Ameren Illinois Company 2022 Business Program Impact Evaluation Report

Appendix D - Custom Initiative Project Reports

Final
April 28, 2023

Figure 4. Ex Ante vs. Actual Fan Speed Profiles for Kitchen Exhaust System

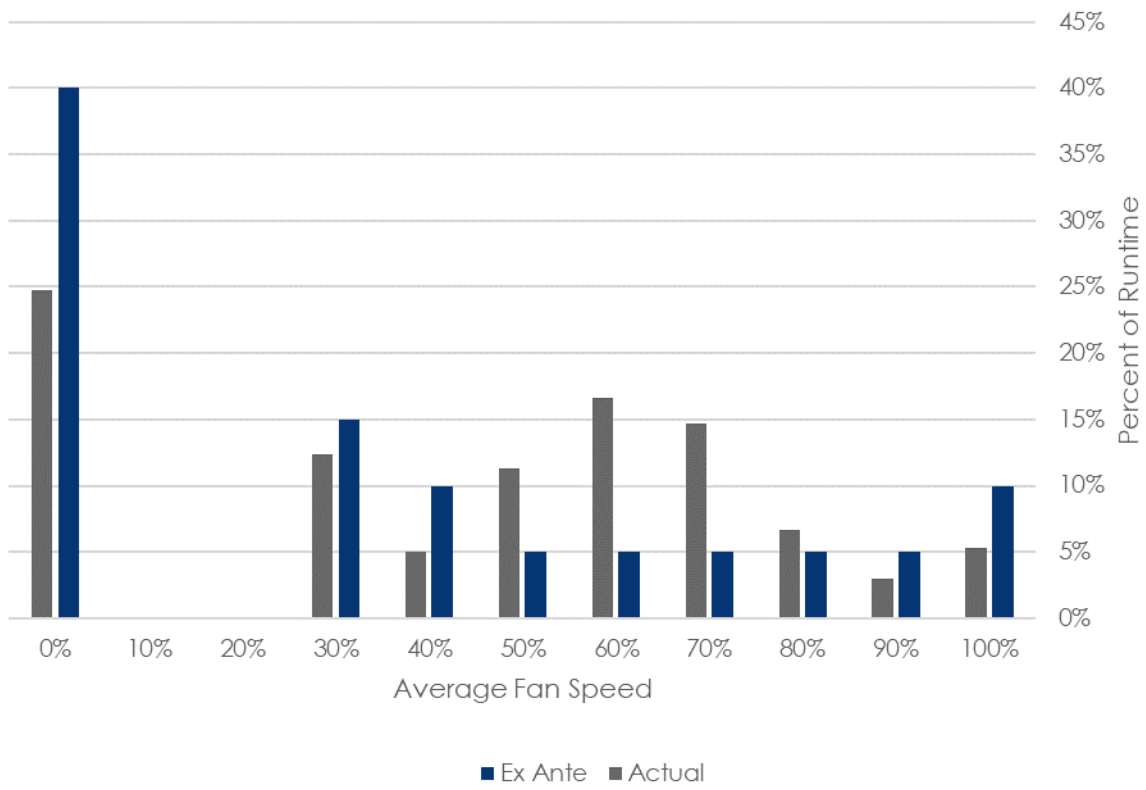
In the kitchen exhaust controls ex ante calculations, the implementation team assumed an average fan speed profile. The evaluation team used the trend data for fan speed and determined the actual profile. The ex ante calculations were updated with the actual fan speed profile, shown in Figure 4, and the same algorithm was used to calculate the verified gas savings.

Figure 16. Control System Screenshot

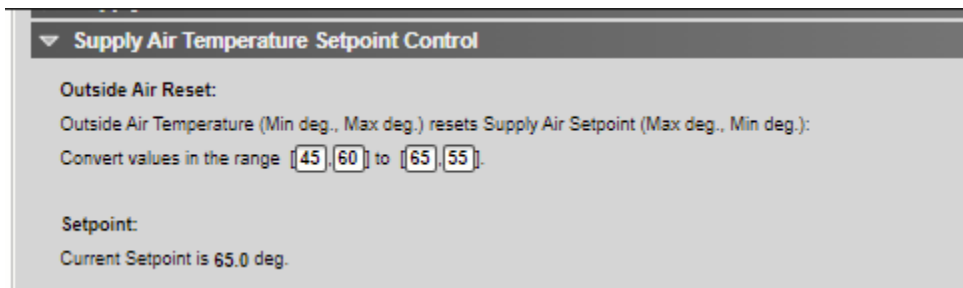
- The evaluation team confirmed the supply air temperature reset control points with the vendor, as shown in Figure 16. The formulas in all the dorm AHU calculations were updated to model the supply air temperature reset correctly. Figure 17 below illustrates the difference between the ex ante and verified DAT reset formulas. Note that the DAT reset inputs were adjusted to match the values shown in Figure 16.
